NRC DOCKET 50-366  
OPERATING LICENSE NPF-5  
EDWIN I. HATCH NUCLEAR PLANT UNIT 2  
BUILDING SETTLEMENT

Your letter of July 20, 1979, requested additional information with regard to our proposed Technical Specifications for settlement of Category I structures. The request for additional information was further clarified in a meeting with your staff on August 30, 1979.

The attached report responds to the questions asked by your July 20, 1979, letter and the concerns discussed at the August 30, 1979, meeting.

FIGURE A.1-1: REFERENCE BENCHMARKS  
(SHT. 2 OF 2)

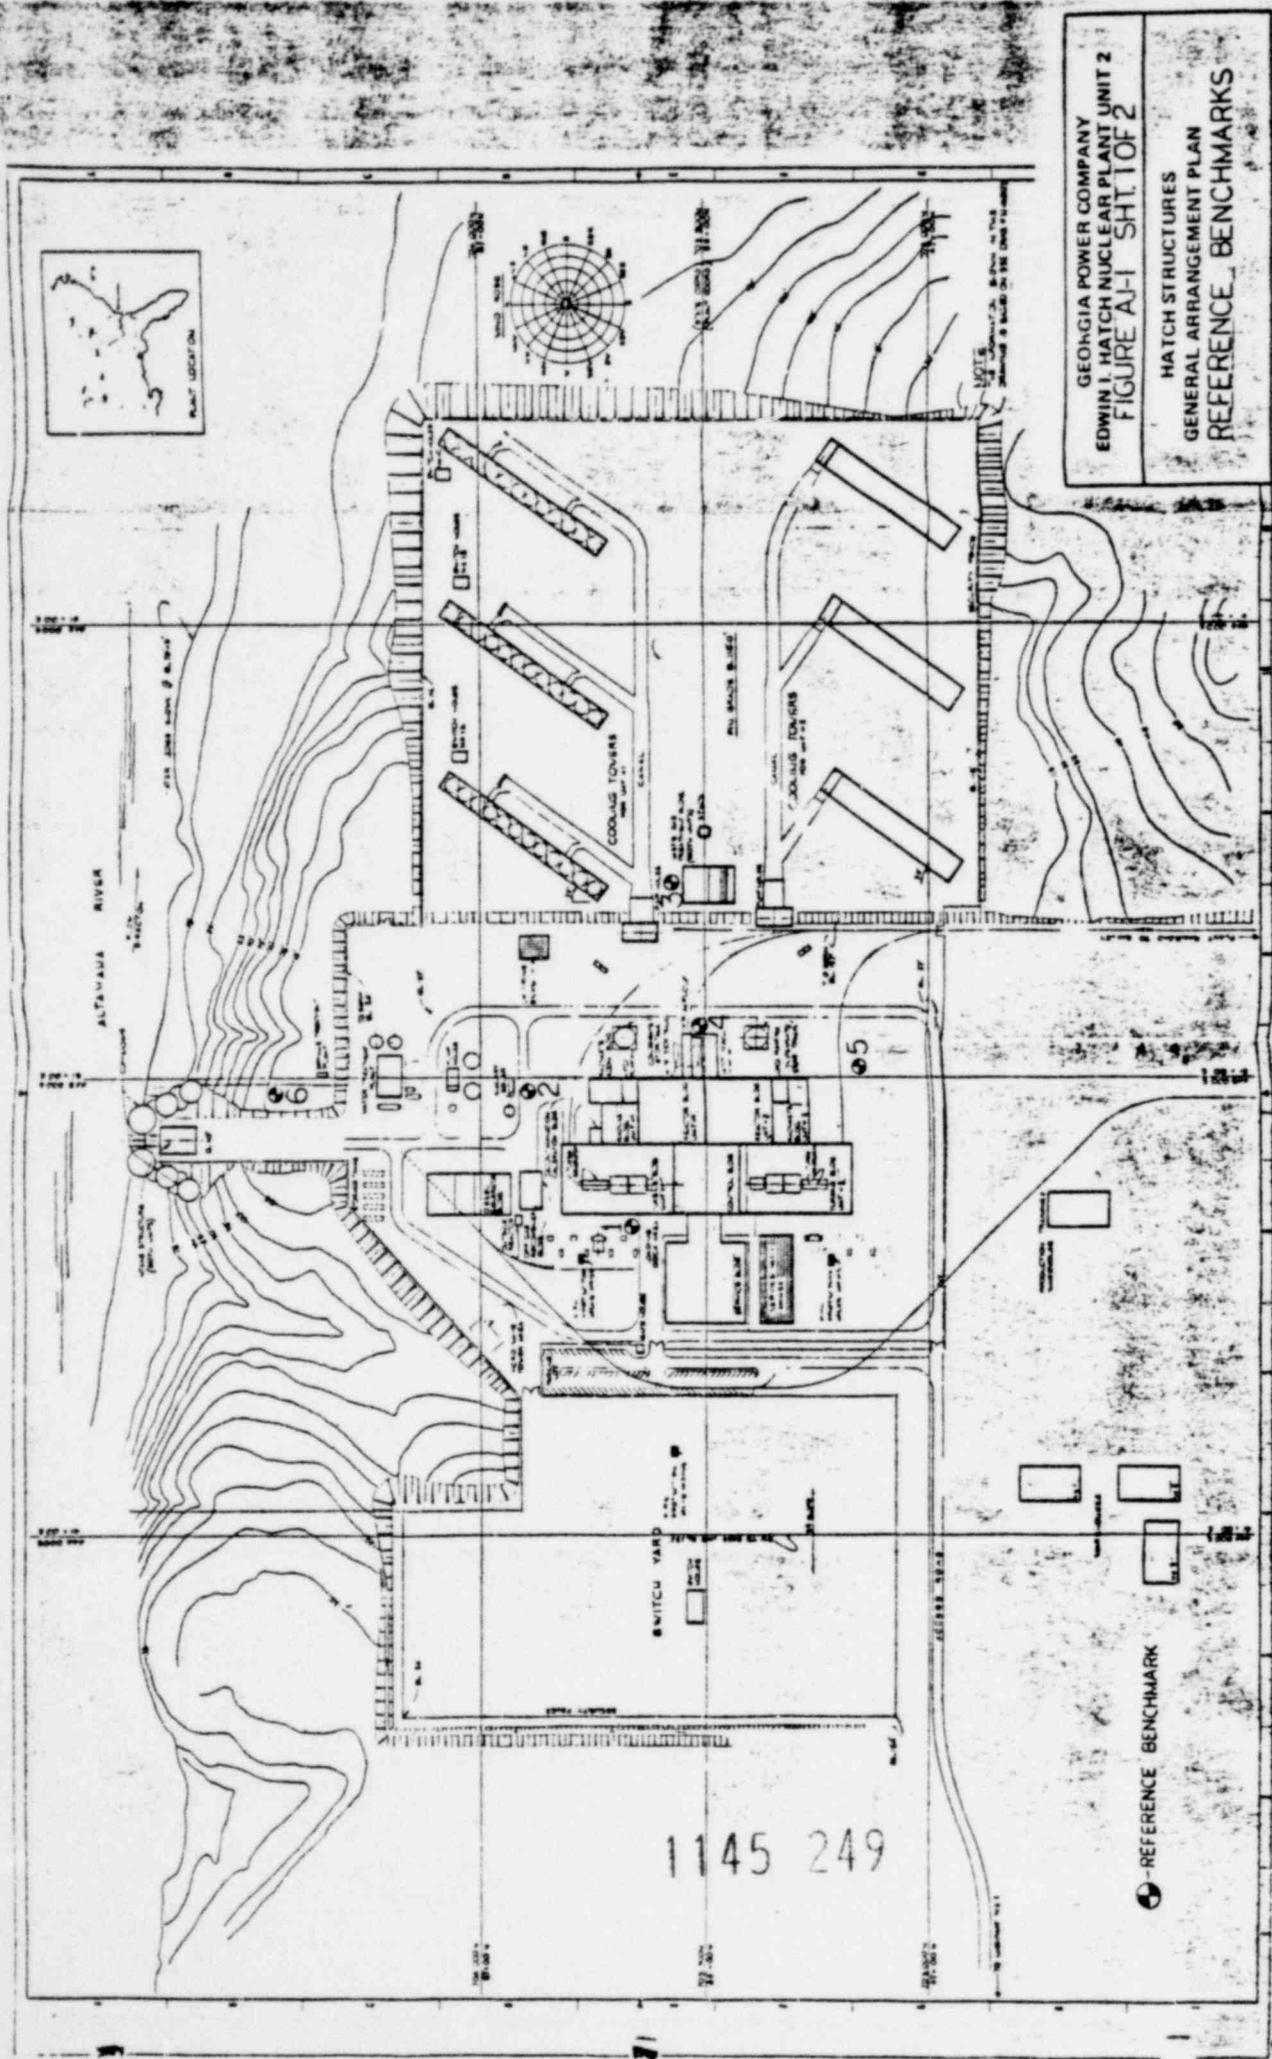
A.1 The locations of the reference benchmarks are shown in Figure A.1-1. Elevations of the benchmarks were originally established from a USGS benchmark in Toombs County. The benchmarks are situated in the yard in such a way as to avoid accidental displacement and facilitate the settlement surveys of the Category I buildings. They are far enough away to avoid settling with the buildings and are placed in areas isolated from traffic which might disturb the marker. Precautions were also taken to provide proper soil and anchorage conditions to ensure the stability of the benchmarks. There is no procedure for periodically checking the elevations of the reference benchmarks.

FIGURE A.4-1: RELATIVE LOCATIONS OF BENCHMARKS AND PENETRATIONS  
 PARTIAL PLAN EAST WALL - EL. 130'-0" - REACTOR BUILDING UNIT 2

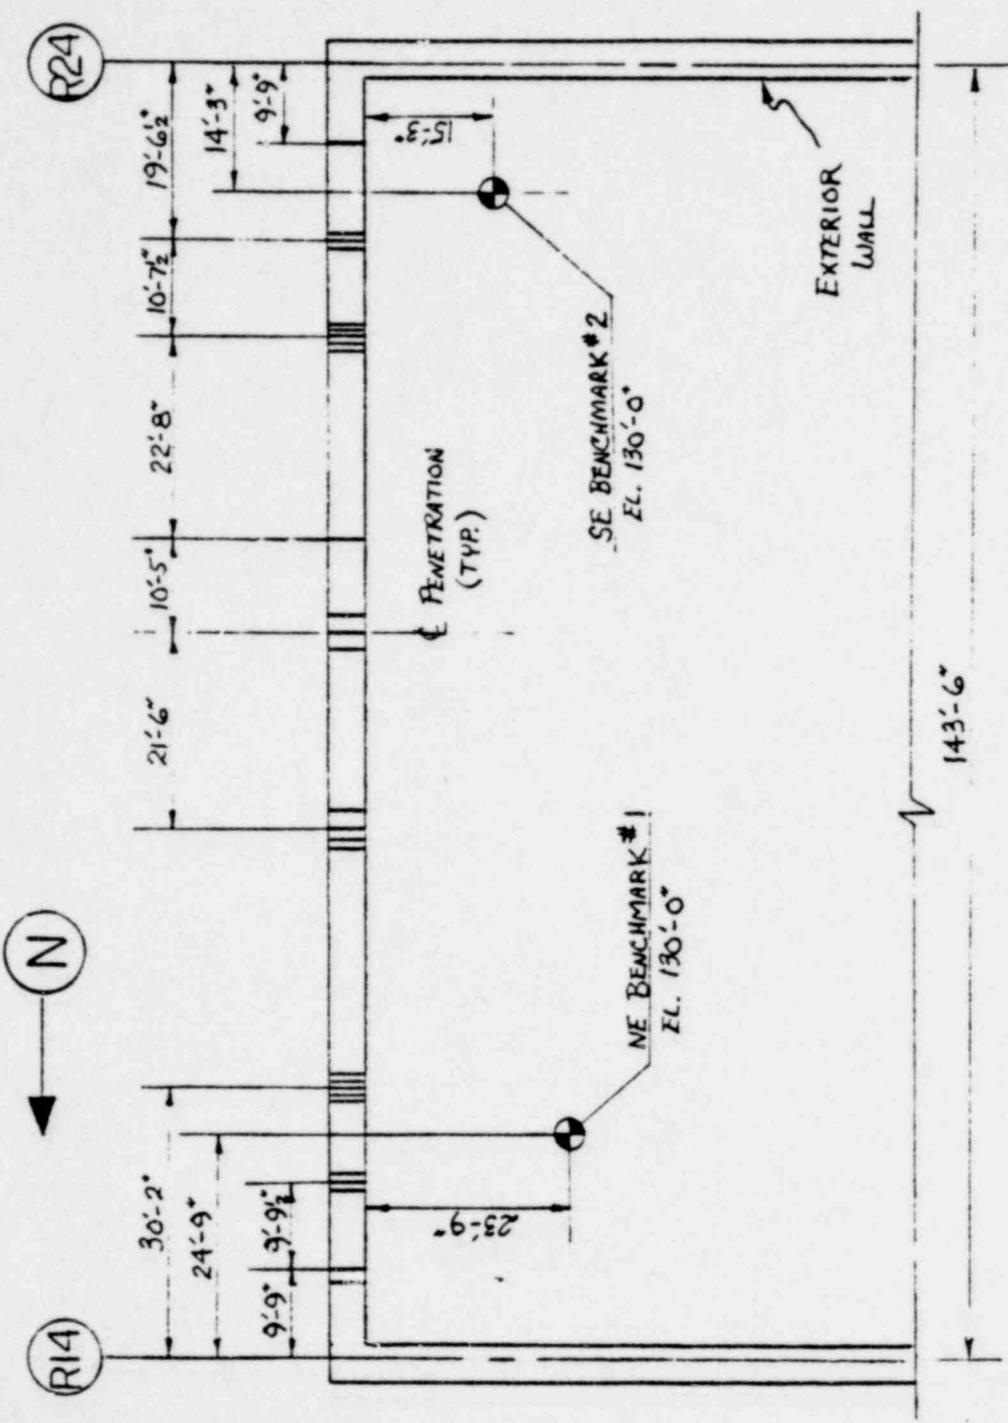
A.4 The relative locations of all penetrations, including electrical conduit penetrations, with respect to the benchmarks for the east wall of the Unit 2 Reactor Building are shown in Figures A.4-1 and A.4-2. The arrangement shown is typical for all the Category I structures.

The assumption made in developing the Technical Specification was that the settlement at a particular penetration was the settlement recorded at the nearest benchmark. Since in almost all cases the piping was installed in the penetrations well after the buildings were complete (see Figures A.6-1 and A.6-2), building adjustments during construction, such as concrete shrinkage, cracking, creep, etc. had stabilized, and therefore what was measured was due to differential settlement. Allowance was also made to allow building settlement to occur before attaching the pipe to the penetration (see bottom detail Figure D.3-2), which would further allow the building itself to adjust.

Linear interpolation was considered for determining settlement values for penetrations located between benchmarks but was determined to be unnecessary in terms of accuracy. Each of the 12 critical penetrations listed in Tables 3.7.8.3-1 and 3.7.8.4-1 of the Technical Specification was examined to determine the difference between using interpolated values of settlement and the values obtained by using the nearest benchmark. In the majority of cases, assuming the value of the nearest benchmark was found to be conservative, or made no difference. For the remaining cases, the maximum amount of difference which could have resulted to date was on the order of 0.004 feet, which is at about the limit of surveying accuracy. Given these results, and the fact that considerably more surveying and subsequent reduction effort would be required if interpolation or extrapolation were used, it is felt that assuming that settlement of critical penetrations is the same as settlement of the nearest benchmarks is appropriate.

FIGURE B.1-1: CONDUIT EXPANSION COUPLING DETAIL

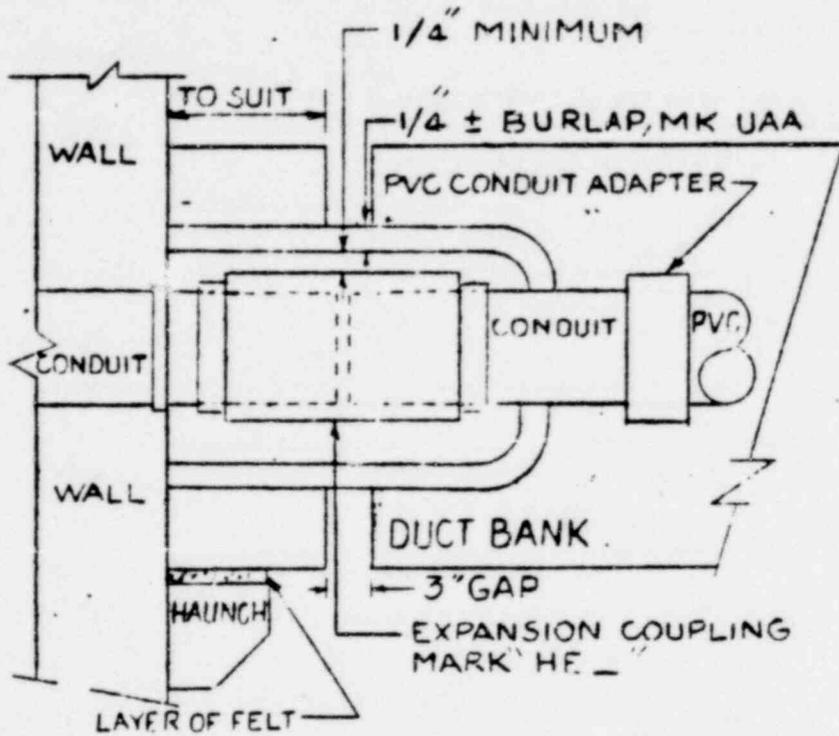
The proposed Technical Specification directly addresses all piping and potential structural damage due to excessive differential settlement. There are electrical conduits which run from the buildings out into the yard and between the structures, but they use flexible connections which allow 3/4" differential movement in any direction per the manufacturer's specification. A typical expansion coupling detail is shown in Figure B.1-1. There are no Category I sheet metal-type ducts which run between buildings or from one building out into the yard.

FIGURE D.3-1: TYPICAL PENETRATION ANCHOR DETAIL 1145 259

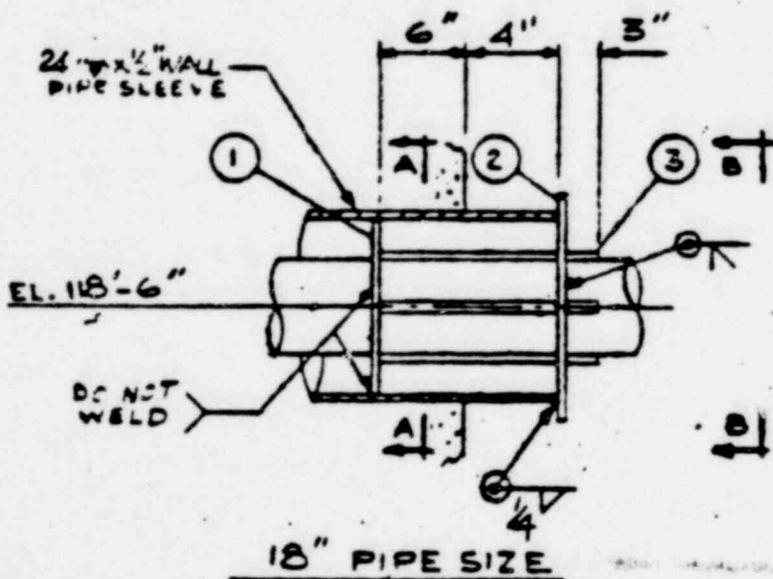
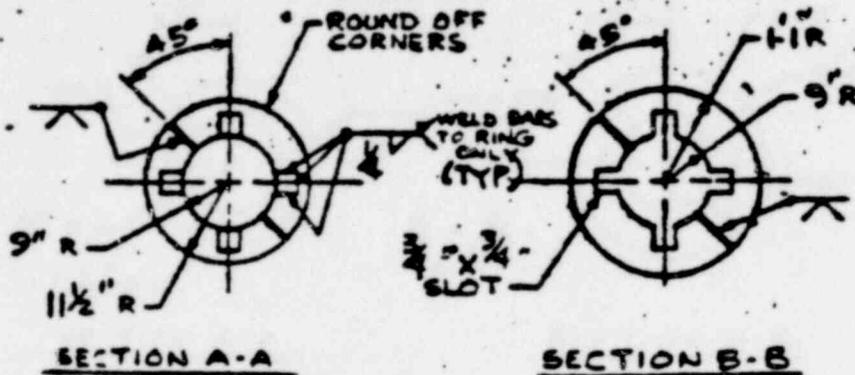
- D.3 A detailed sketch of a typical penetration anchor is shown in Figure D.3-1. As is shown, the anchor is located at the interior side of the wall penetration. Additional penetration details are shown in Figure D.3-2. A description of each penetration type is provided in the figures.

By definition, the penetration anchors are designed to take moments, shears and axial loads. They are not constituted of snubber-like devices although an effort was made to reduce the load on the anchors due to building settlement by allowing the building to settle as much as possible before setting the penetration anchor (see bottom detail of Figure D.3-2). The HNP-2 FSAR Section 3.9 covers the design and analysis requirements for the HNP-2 Class I piping. The load types and loading combinations used in the original design of the piping and piping supports are those found in the Winter 1972 Addenda to the ASME Boiler and Pressure Vessel Code, Section III, 1972. The loads considered were sustained, dynamic, and thermal and combinations of the three. The safety margins provided by the anchors are the margins provided by the ASME Code, 1972. Stresses due to building settlement were not considered either in the FSAR or the revision of the ASME code that the original design was based on.
